Division 5.2 and EPBC Act Approval

Modification Assessment

**The Northern Road Upgrade – Mersey Road,
Bringelly to Glenmore Parkway, Glenmore Park**

December 2018

Figure 2-3 Comparison of SPIR and Final EIS and refined design operational footprints

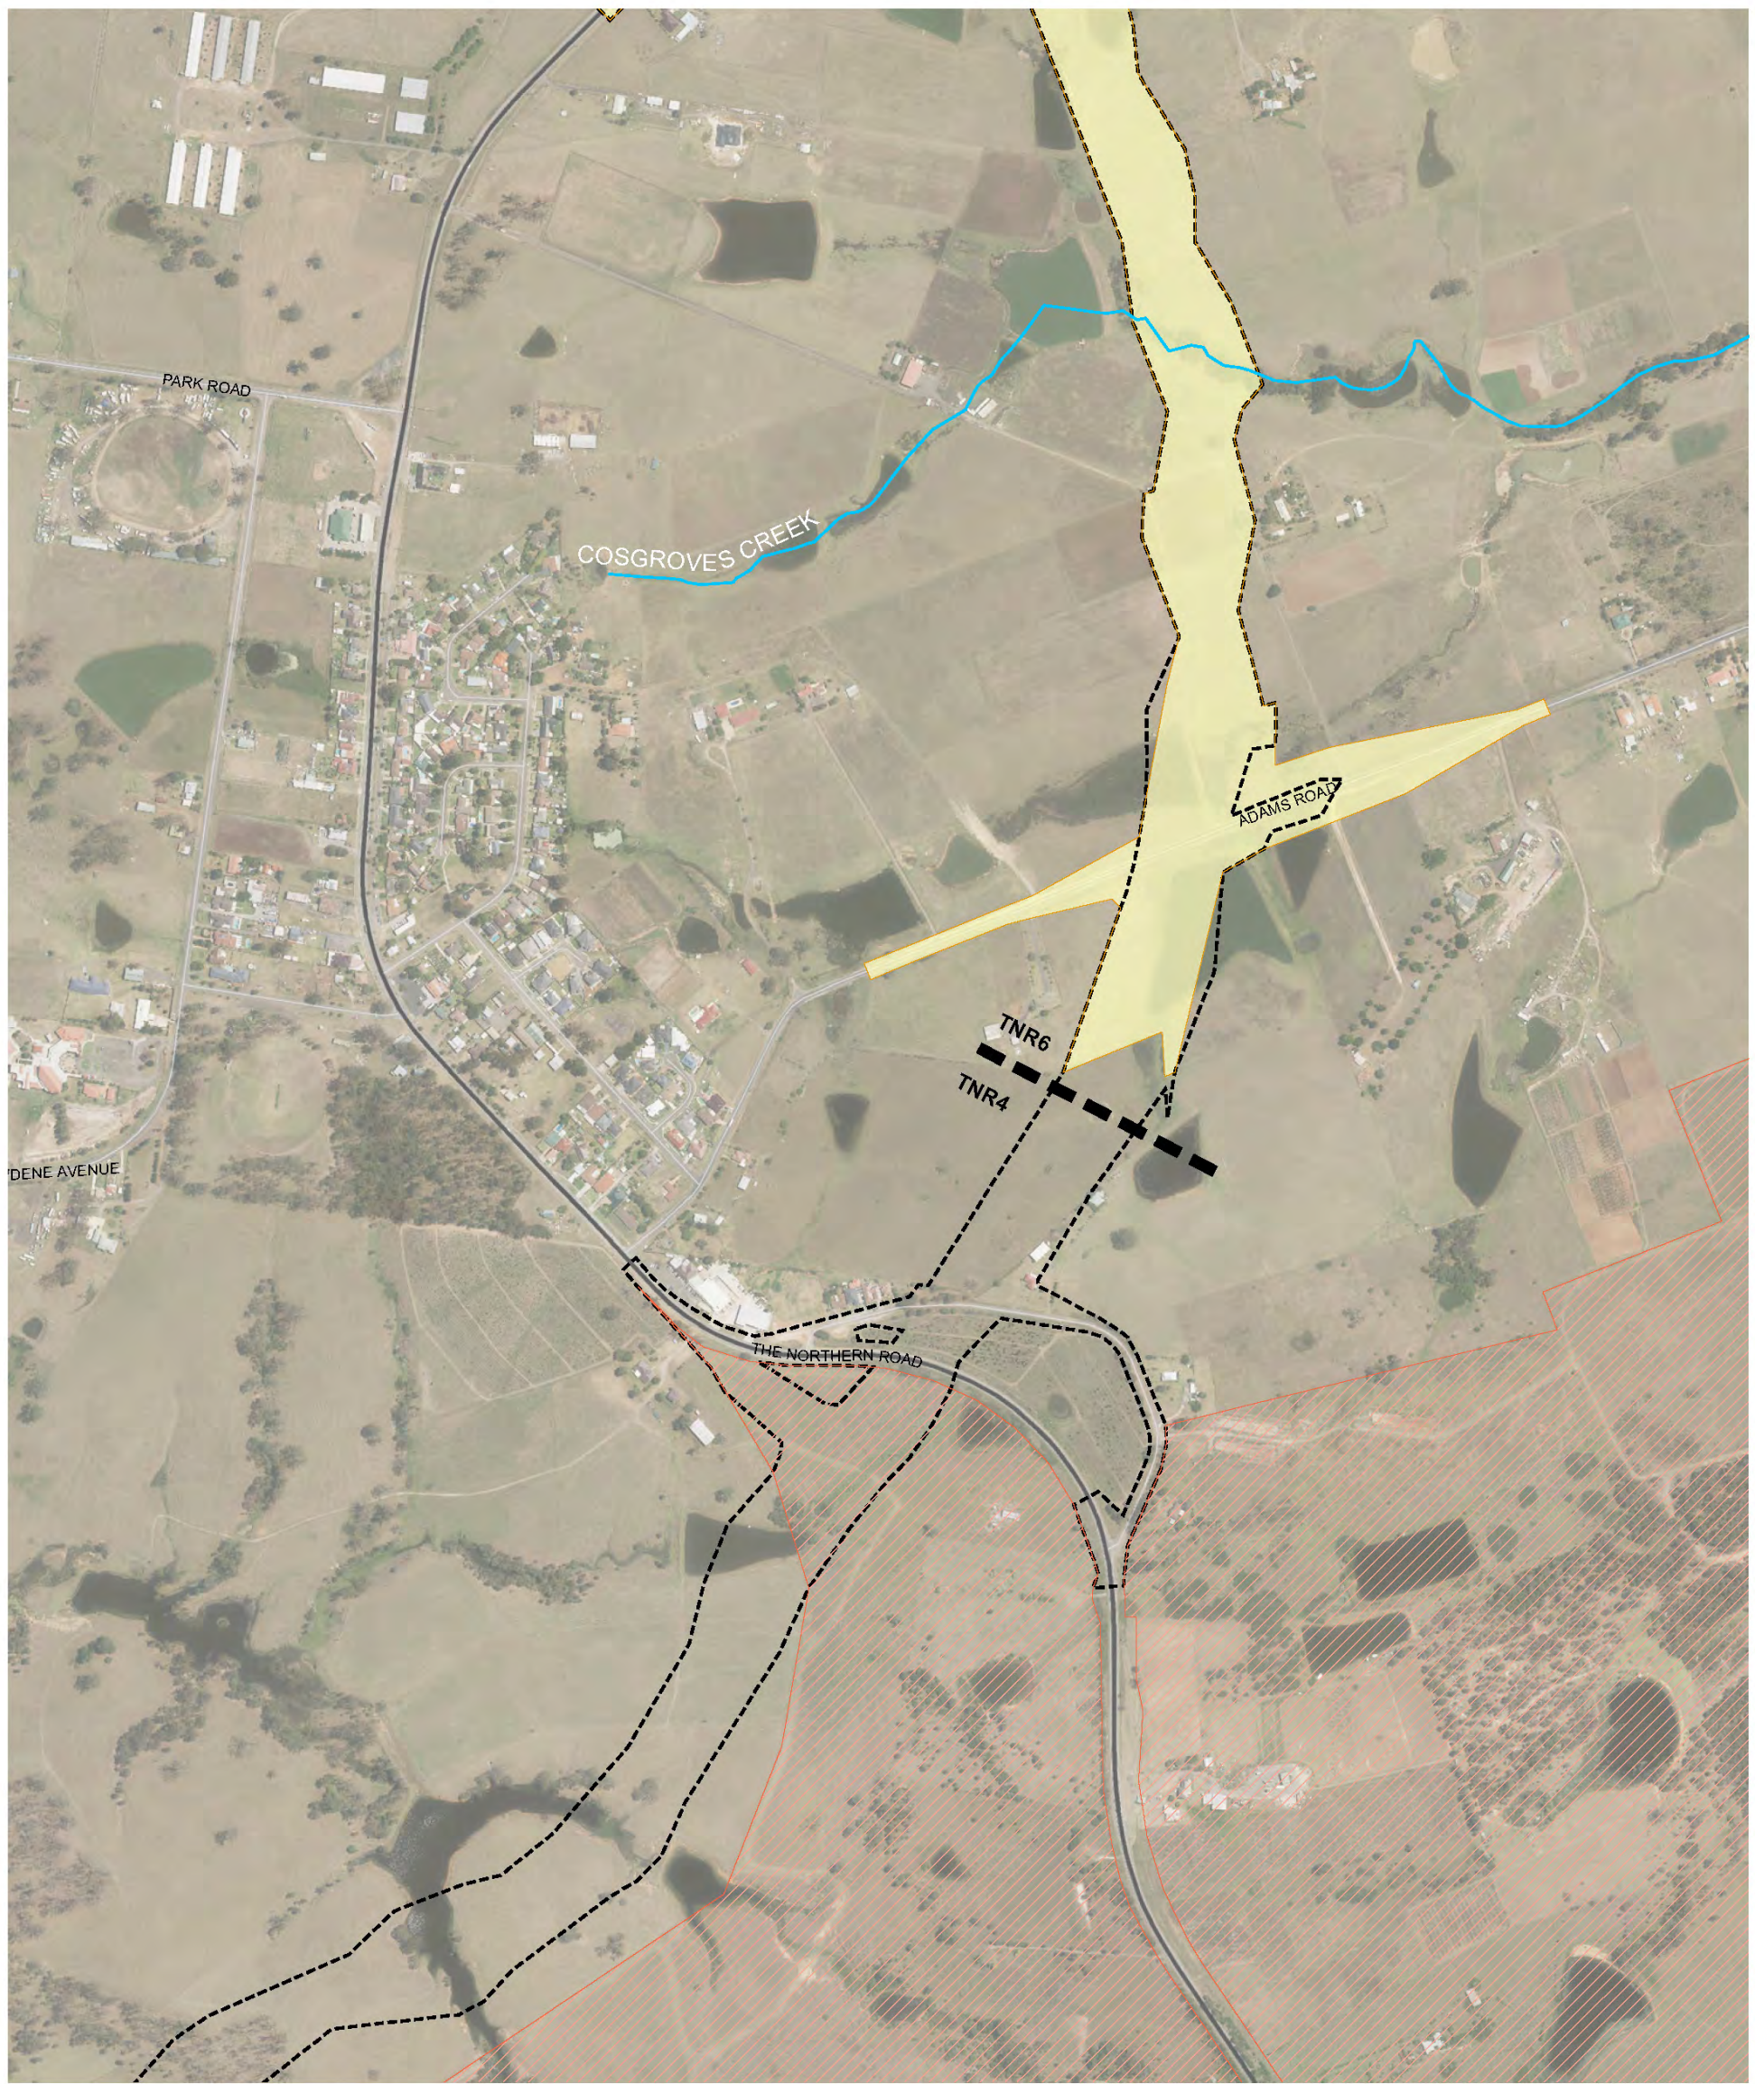
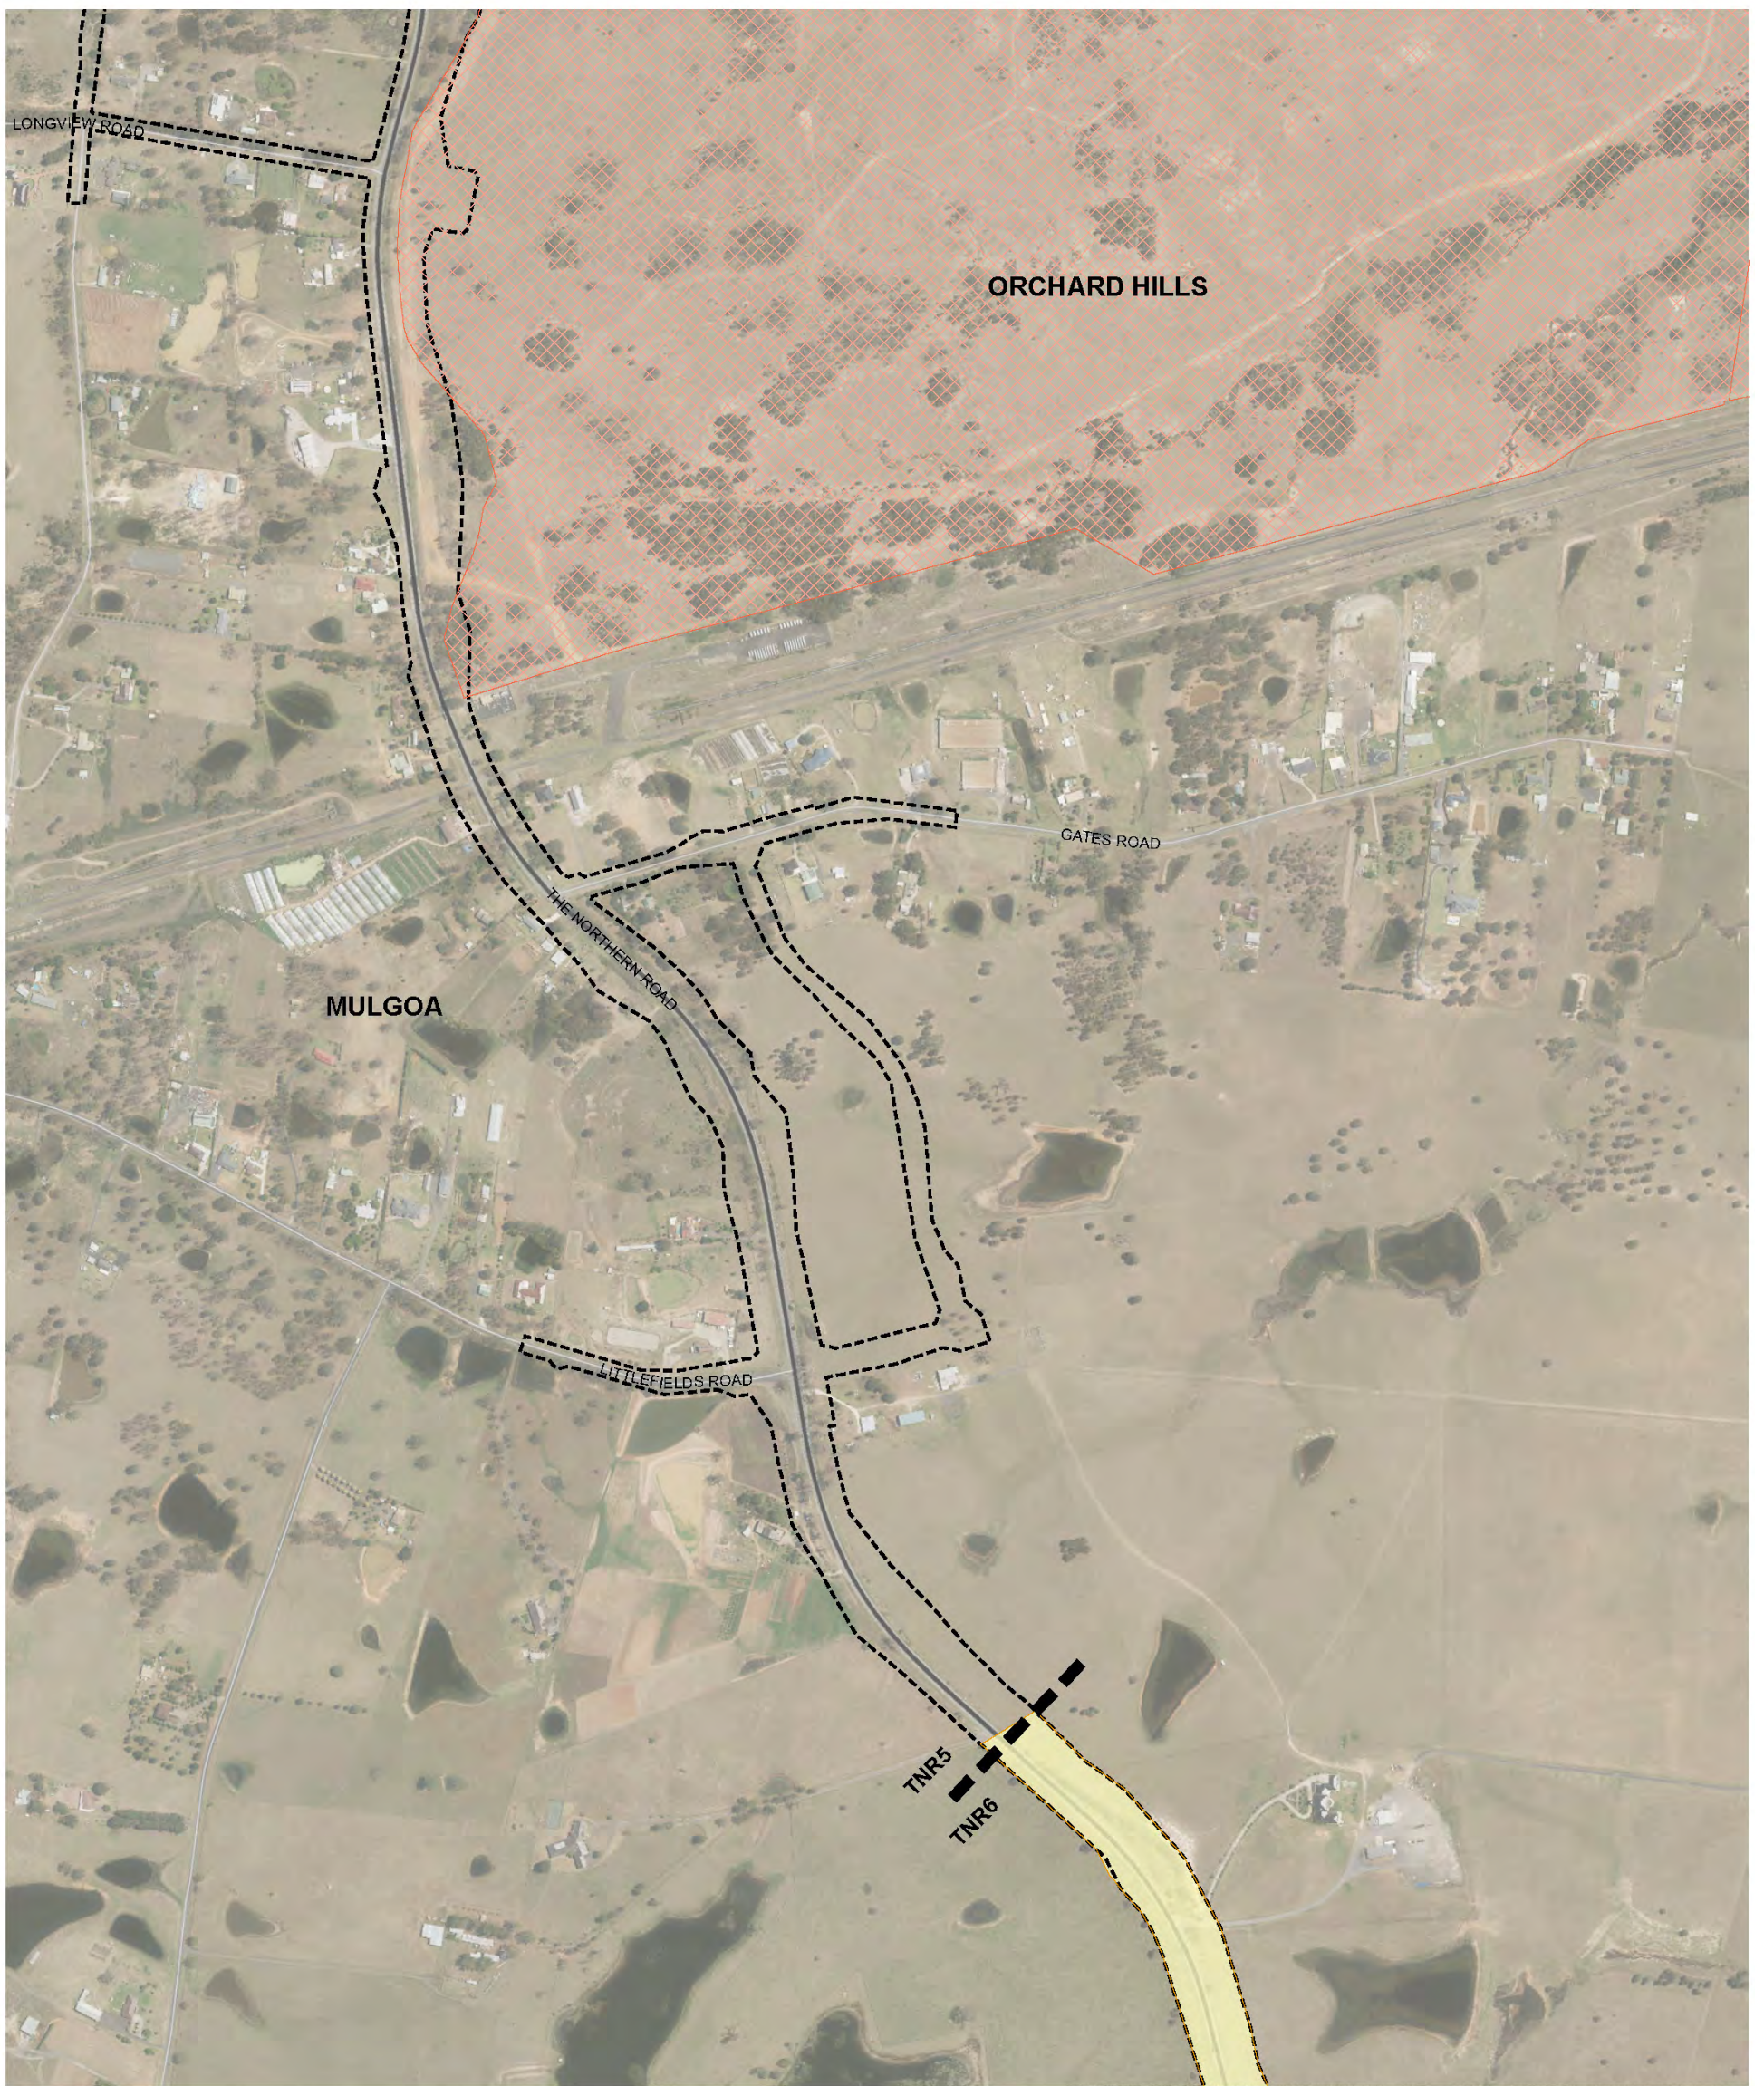
Proposed changes to the approved construction and operational project boundaries are shown in Figure 2-2 and Figure 2-3 and are limited to:

- An increased construction and operational footprint around Adams Road to enable the regrading of this road
- Minor increases to the construction boundary to allow private property access adjustments
- A reduced footprint for the ancillary facility area (and associated construction boundary) at the south-eastern corner of Elizabeth Drive and The Northern Road intersection
- Slight rationalisation (reduction) of the operational boundary at three locations based on the minor vertical, horizontal and cross-section alignment refinements proposed and consultation with affected property owners to reduce and simplify property acquisition.

Figure 2-4 Options assessment figure – Option 1 A signalised intersection

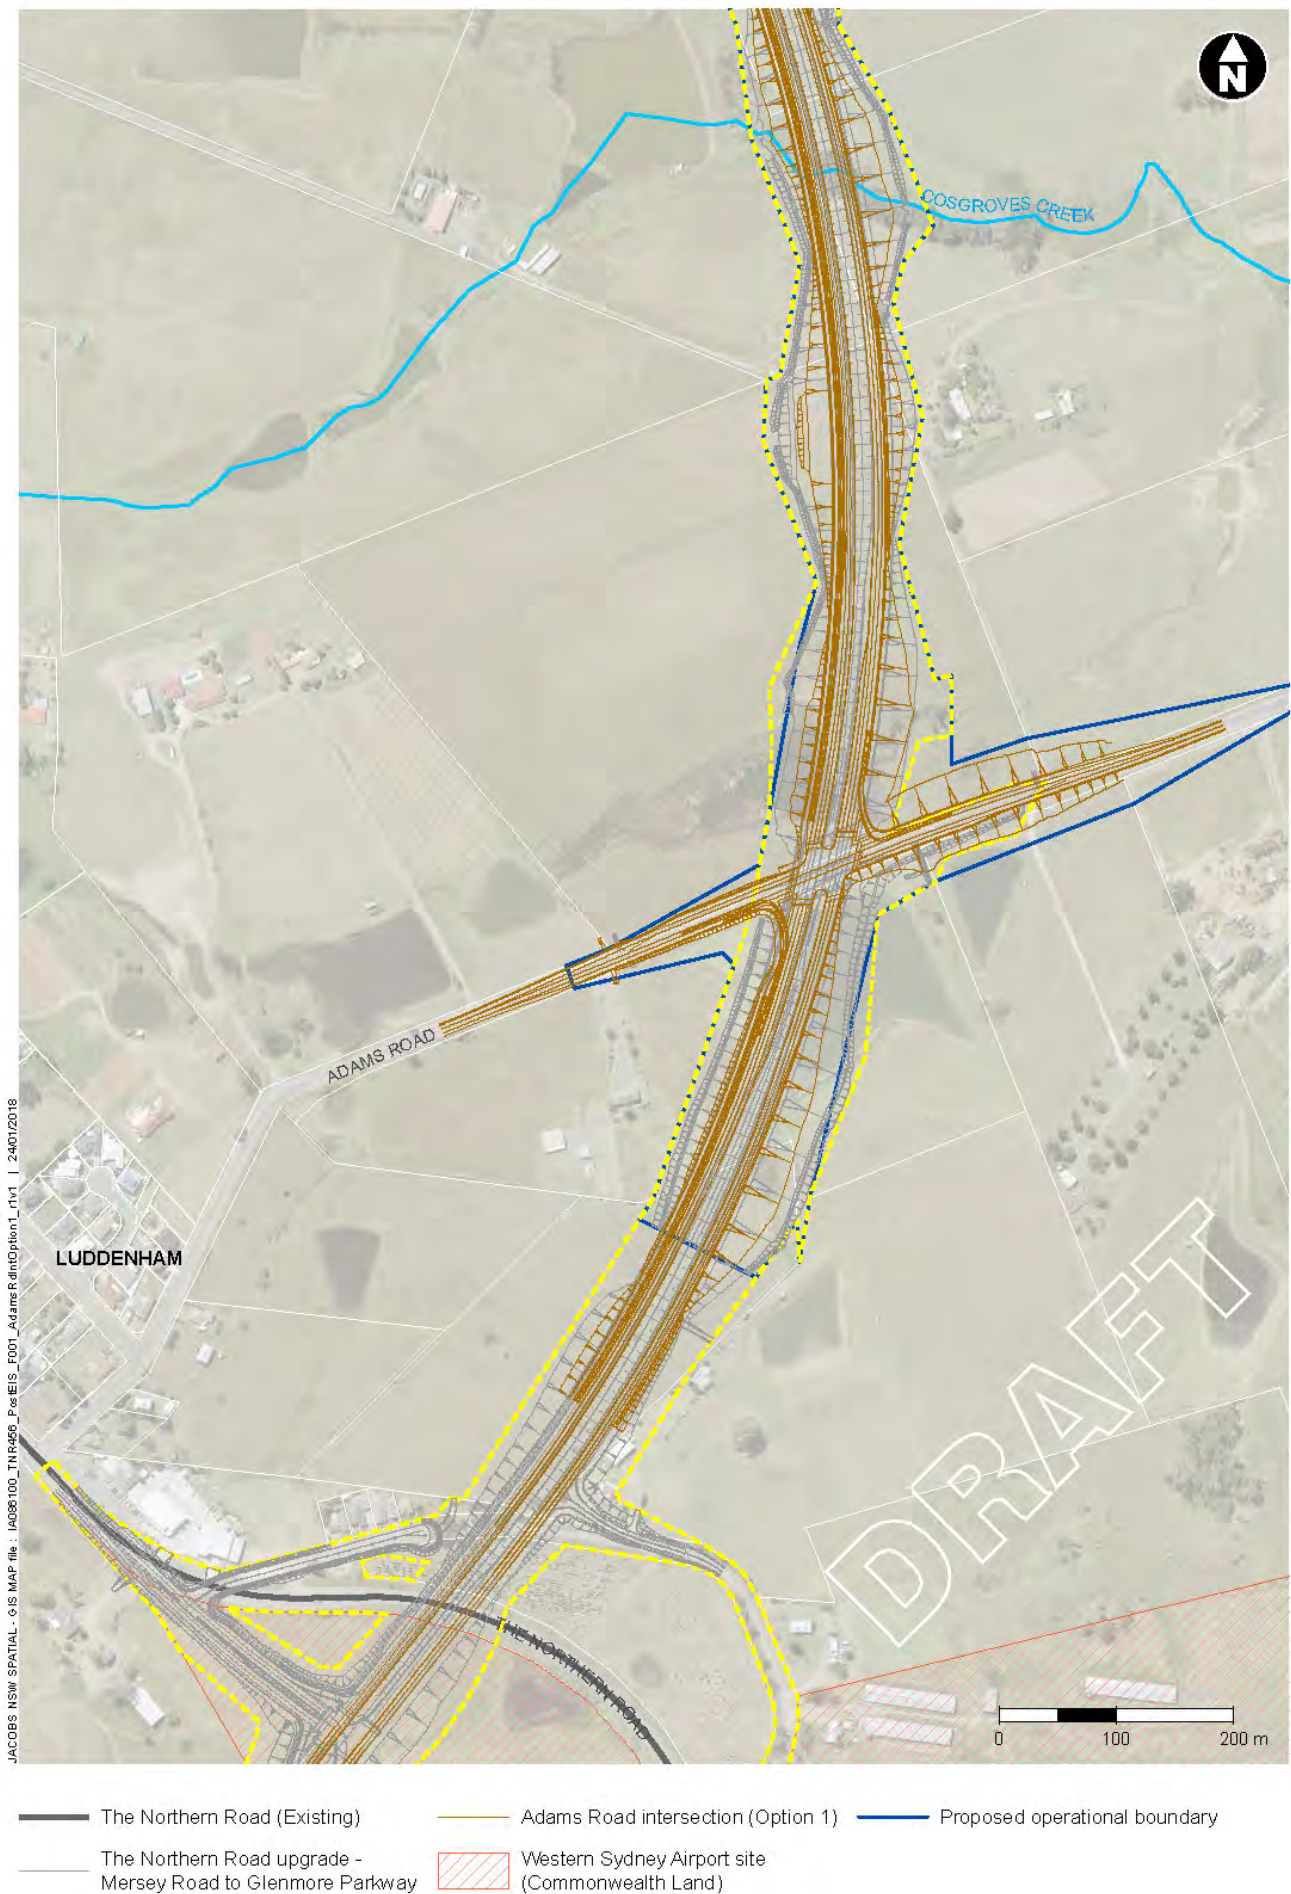
The selected option was Option 1, a signalised intersection with Adams Road. A full description of the option is provided in Section 2.2.

After the display of the proposed modification, one small design change was made. Instead of a combined straight and right turning lane, an additional dedicated right turning bay from Adams Road into The Northern Road was added, on both sides of the intersection.
